# Imray Correction Notice ICY17B-1

## Chart **Y17B** WGS 84

*Edition 2022*

Block correction for Y17B  
 ILNW 20/23

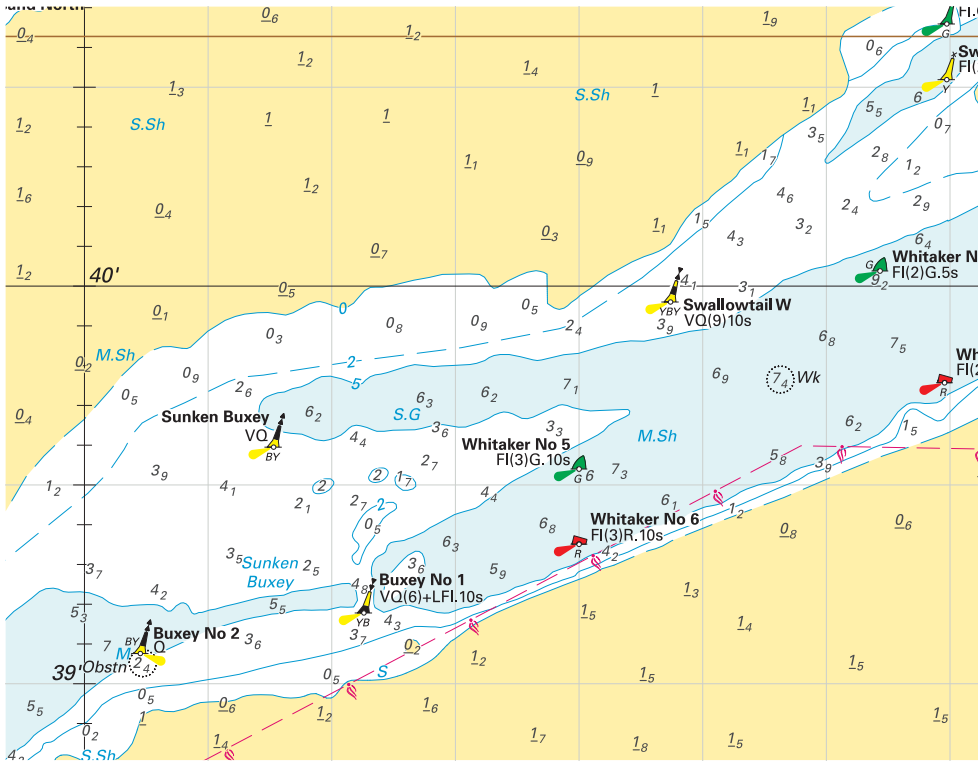
#### 3 **Sunken Buxey, Approaches to River Crouch**

Insert accompanying block correction centred on 51°39'·76N 1°01'·65E (ILNW 20/23)
